UNITED STATES PATENT AND TRADEMARK OFFICE

APPLICATION NO.		FILING DATE	FIRST NAMED INVENTOR	ATTORNEY DOCKET NO.	CONFIRMATION NO.	
10/617,026		07/11/2003	Seung-Woo Lee	6192.0302.US	2713	
32605	7590	06/02/2006		EXAMINER		
		WOK CHEN &	MOON, SEOKYUN			
	62 TECHNOLOGY DRIVE, SUITE 226 N JOSE, CA 95110			ART UNIT	PAPER NUMBER	
57111002	, 011 20	•••		2629		
				DATE MAILED: 06/02/2006

DETAILED ACTION

Drawing 1

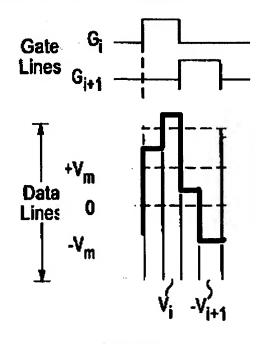
As to **claim 2**, Lien teaches two data voltages sequentially applied to the data line have opposite polarity with respect to a predetermined voltage ("0V") [drawing 1 provided below] and the slave driver [fig. 3] inverts the polarity of the stored voltage before application to the data line [col. 5 lines 38-54].

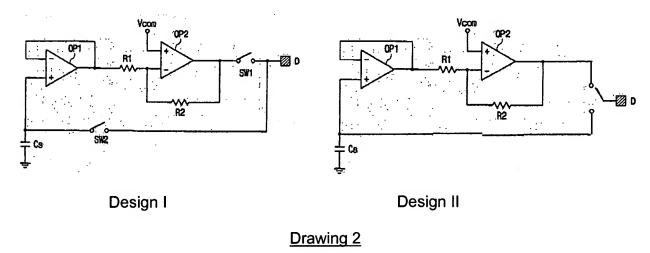
However, Lautzenhiser [fig. 21] discloses an inverter ("inverter 350") comprising an operation amplifier ("operational amplifier 354") in a negative feedback configuration having a non-inverting input terminal supplied with the predetermined voltage ("ground") [par. (0223)].

It would have been obvious to one of ordinary skill in the art at the time of the invention to specify the internal structure of Lien's inverter in such way, as taught by Lautzenhiser, since including an operation amplifier in a negative feedback configuration to implement an inverter is well known and widely used in electronic circuit design.
